Building Deficiency Review

at 323 George Street, Coburg, ON

Final Submission

PROJECT # 6383-01

Figure 1: Approximate Locations of Column Openings, East Elevation

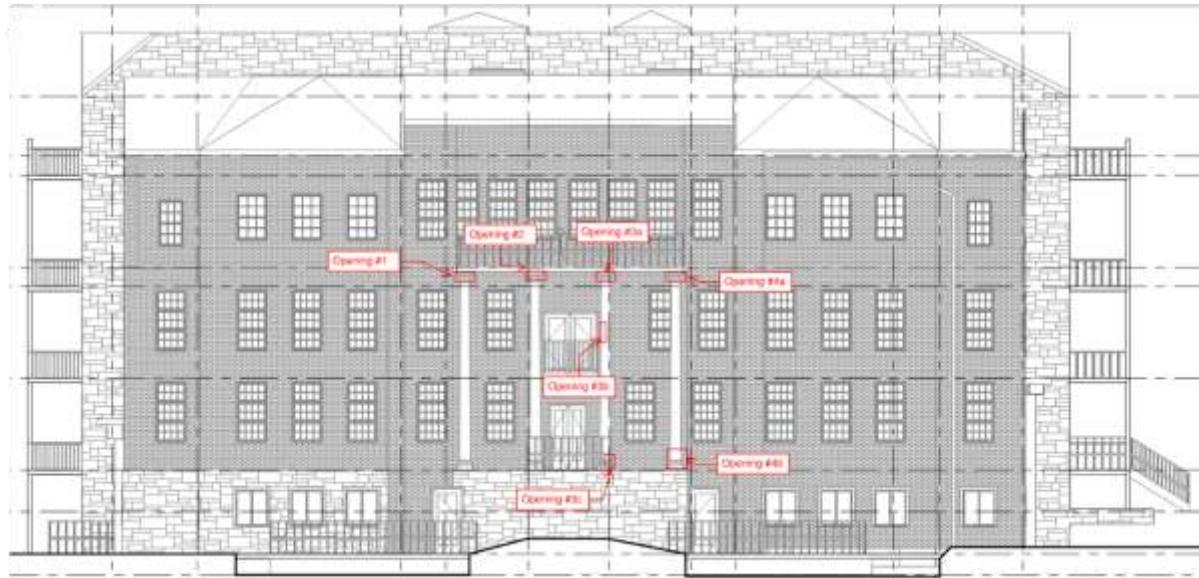
- Four (4) openings were located at the tops of the columns, one at each column all the way around where decorative elements had been previously removed. There was also one (1) mid-height opening at the third column from the south, and 2 lower openings at the third and fourth columns from the south *Figure 1. (Photo 4)*

Figure 2: Sketch of Expected Parapet Configuration

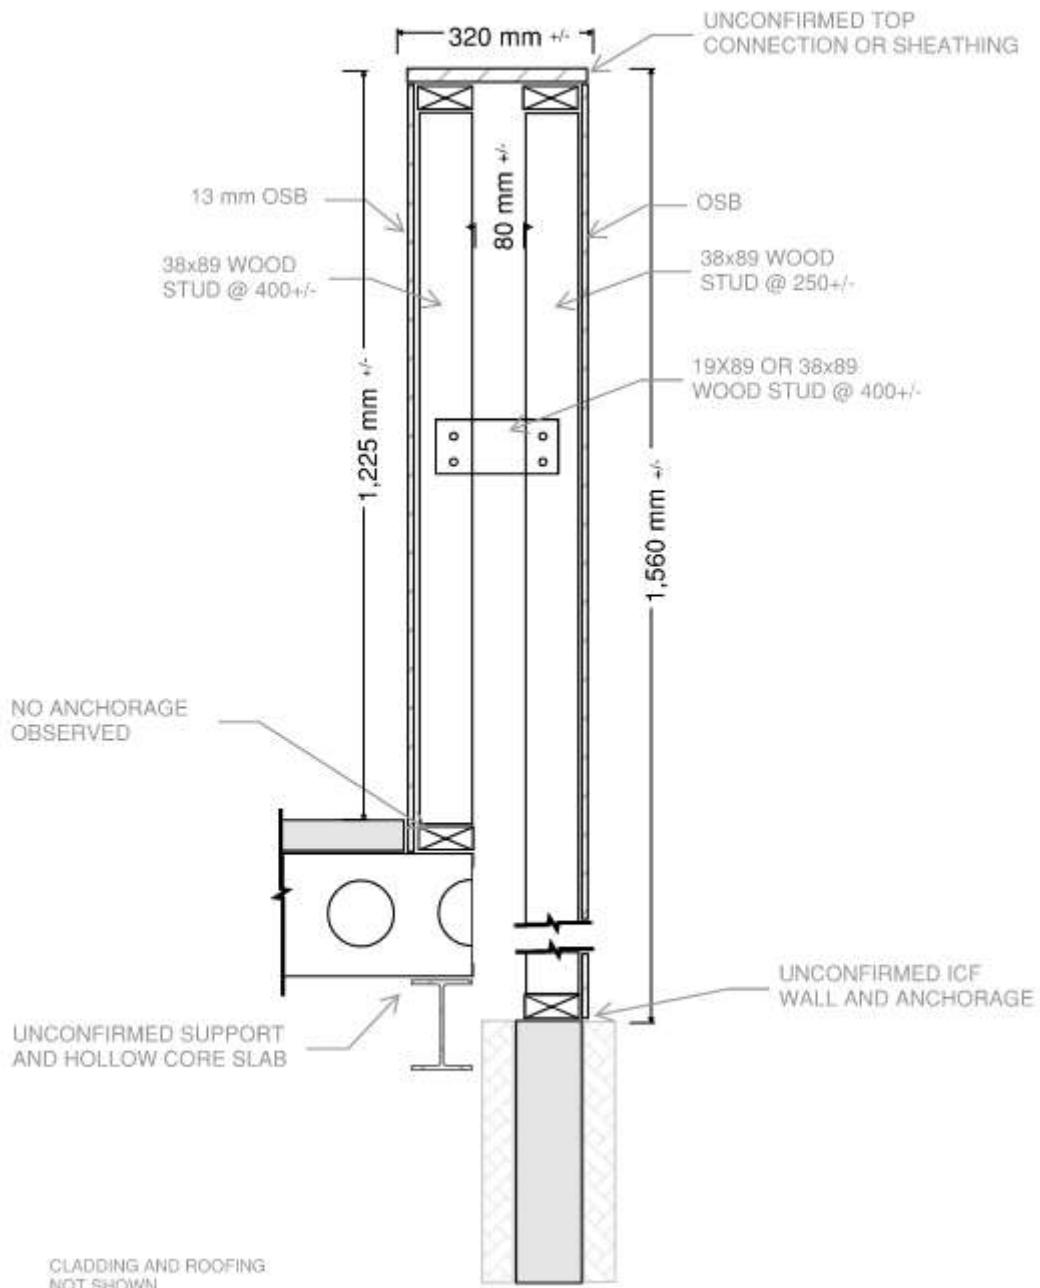
An exploratory opening was conducted at the parapet at the west roof. An opening approximately 300 mm x 600 mm was made at the interior face of the parapet wall near the roof line. (Photo 12 & Photo 13) The following observations were noted regarding the structure, refer also to Figure 2. Refer also to architectural report.

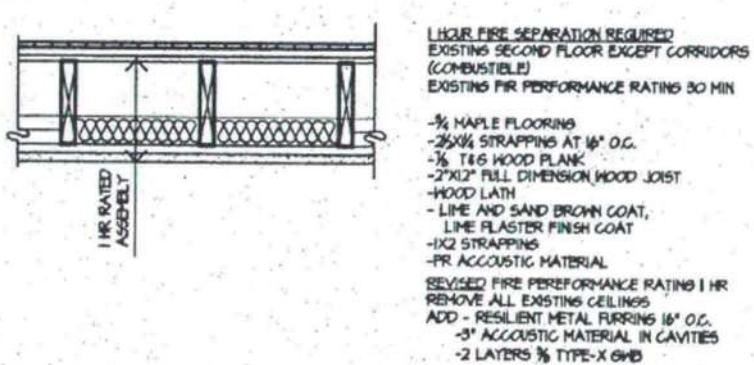
The above image is a floor assembly that claims a 1-hour rating. However, the architect has not provided a code or ULC reference to support this claim. The assembly indicates a 30minute rating for the historic plaster ceiling, which is to be left in place and have a sheet of fire-rated drywall affixed overtop. This is not permitted. SB2 of the Ontario Building Code does allow for the use of built-up assemblies; but it is a stand-alone tool and cannot be combined with historic assemblies. To properly use the built-up method of SB-2, two layers of 5/8" Type X gypsum would have been required. As a result, any floors constructed in this manner cannot be considered to have the required fire-rating.

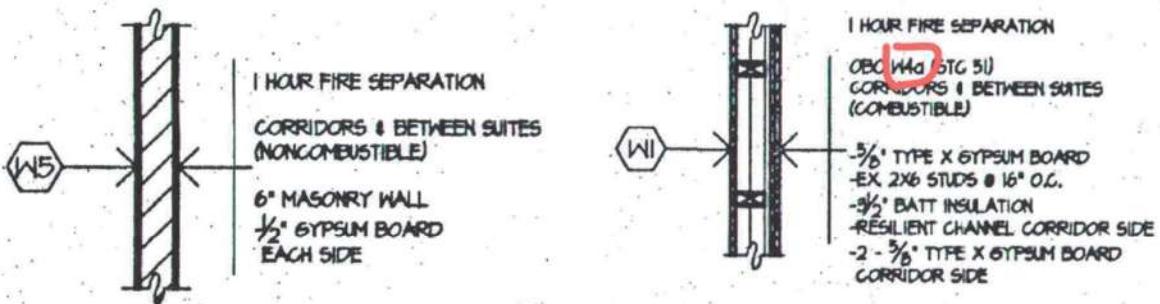
The above wall assemblies do not include code or ULC references. On the left, it is unclear whether the 6" masonry core is new or existing, or whether it is hollow-core or monolithic. On the right, the rating is applicable to Part 9 (small construction) buildings only and should not be used in this instance. We would need to perform additional investigations to determine in there is an applicable assembly that could be

retroactively applied to these wall assemblies. As designed and annotated, they do not currently meet the requirements of the OBC.

1 HR FFR FOR STEEL BEAM
SCALE: 1"=1'-0"

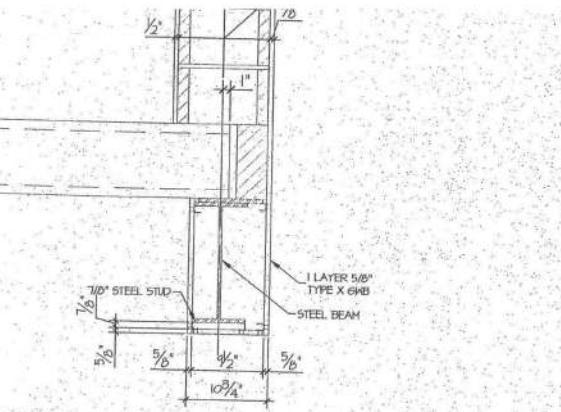
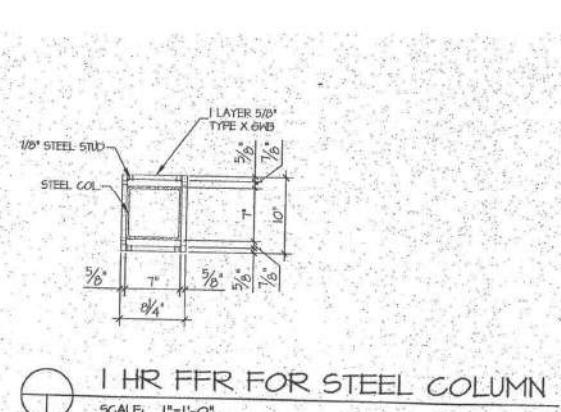
The above images are the fire protection details for steel beams and columns, respectively. Both details are assigned a 1-hour rating, but the detail is incorrect: two layers of Type X gypsum is required to achieve the required rating. Based on these details, it is possible that the steel beams and columns throughout the building are not provided with adequate fire protection.

The above image is extracted from the ULC catalogue of approved fire protection details for steel beams and columns. The detail clearly indicates that two layers of gypsum is required to achieve the 1-hour rating.
